**COUNTY OF LOUDOUN**

**MEMORANDUM**

**SUBJECT: ZMAP-2005-0038 The Townes at Autumn Oaks**

DATE: September 13, 2007  
TO: Mike Elabarger, Planning Project Manager  
FROM: Laura Edmonds, Environmental Engineer  
THROUGH: William Marsh, Environmental Review Team Leader  
CC: Michael Salinas, Community Planner  
SUBJECT: **ZMAP-2005-0038 - The Townes at Autumn Oaks – 2<sup>nd</sup> Referral**

**GRAPHIC 2: LOCATION OF THE TOWNES AT AUTUMN OAKS VS. PEARSON CPAM**

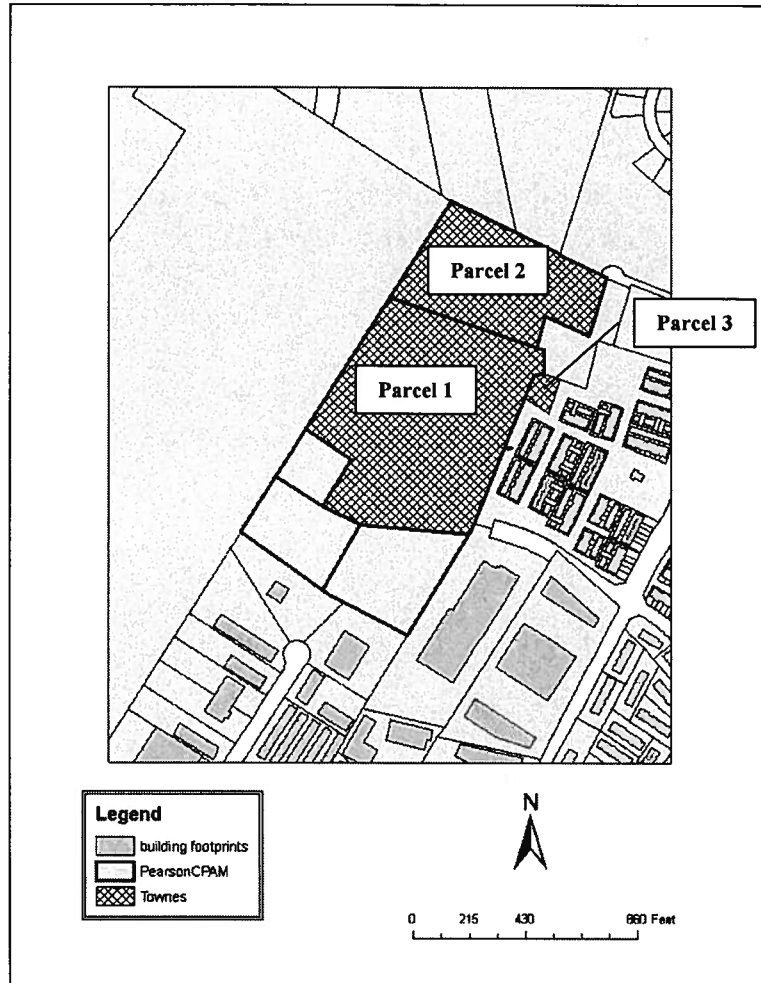
As shown above in Graphic 2, the Pearson Reserve Comprehensive Plan Amendment (CPAM 2004-0007) amended the Revised General Plan's Planned Land Use Map to designate HDR within the Route 28 Highway Tax District on five specific parcels totaling approximately 24 acres at a maximum density of 8 dwelling units per acre. Two of the three parcels that make up the subject site are governed by the Pearson Reserve CPAM. The third parcel, approximately .29 acres in size, is not associated with the Pearson Reserve CPAM, but is part of the larger Oak Grove area of the Route 28 Tax District where residential land uses within the tax district are allowed at a maximum density of 4 dwelling units per acre (Revised General Plan, Policy 3, p. 6-17). The applicant has chosen not to place residential land uses on the small parcel (.29 acres). Table 1 below summarizes the proposed densities, based on a total 115 du's and exclusive of Affordable Dwelling Units (ADU's), for that portion of The Townes at Autumn Oaks planned as HDR.

**GRAPHIC 4: INTERMITTENT STREAM ON SUBJECT SITE**

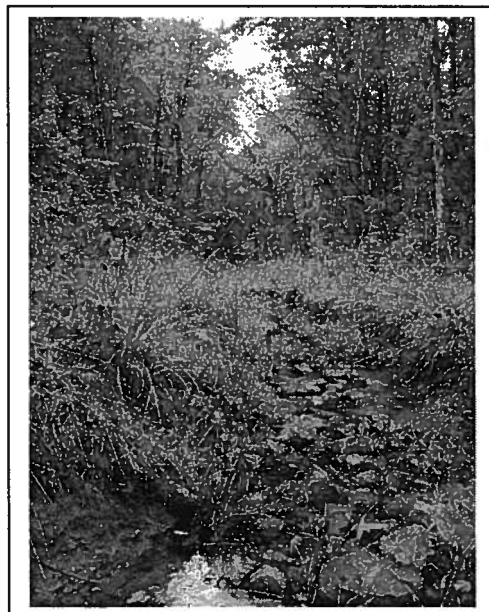
***Staff supports the applicant's protection of the intermittent stream and its associated wetlands by preserving the area as natural open space. Staff recommends the applicant commit to stream bank and stream bed restoration that will improve its ability to adequately convey stormwater run-off and enhance the natural and aesthetic functions of the stream corridor.***

GRAPHIC 5: TYPES OF PUBLIC SPACE

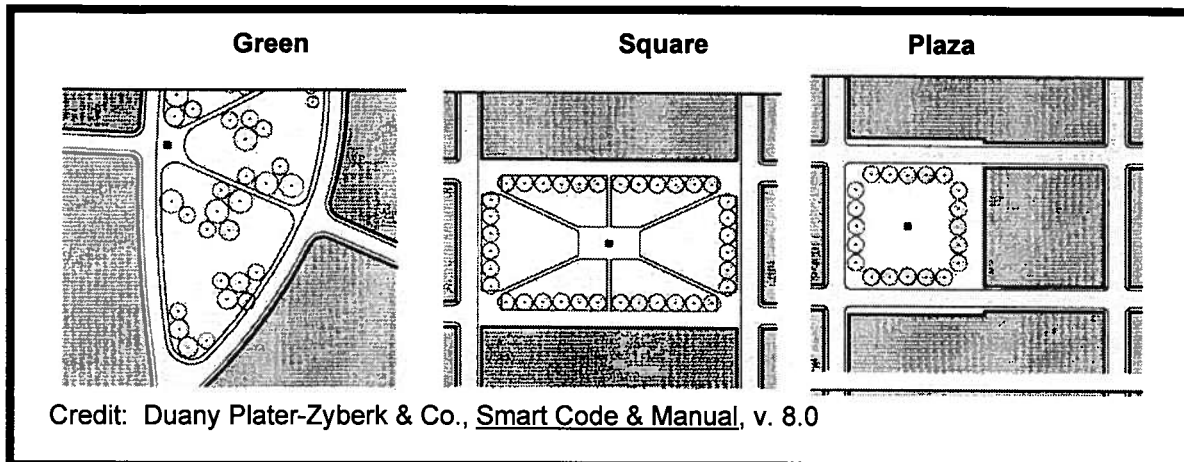
Staff recommends the applicant consider relocating the development's town green/civic space closer to the geographic center of the development. One suggestion is to redesign the open space the applicant has currently designated in the central part of the development into the main open space of the neighborhood – either as a square, plaza, or green. As currently proposed in the CDP, this interior open space is completely contained by the rear elevations of dwelling units located along the entire perimeter of the block – isolating the space from the rest of the development. The open space can be redesigned into the main public space of the development by opening up at least 50% of the block perimeter to the surrounding streets. If a more formalized square or plaza is proposed, the space can be spatially defined by fronting buildings and public frontages including streets, sidewalks, and trees. A square tends to have a mix of paths, lawns and trees whereas plazas tend to be primarily pavement. A green, on the other hand, is a less structured park used primarily for passive recreation that can also be spatially defined by more naturalistically disposed landscaping. Designed as a square, plaza, or green, the main public space of the development can function as the central gathering place for residents.

Graphic 5 below provides a diagram of the types of main public space that can be incorporated into the development. Graphic 5 also shows differences in each related to size, spatial definition and landscaping.
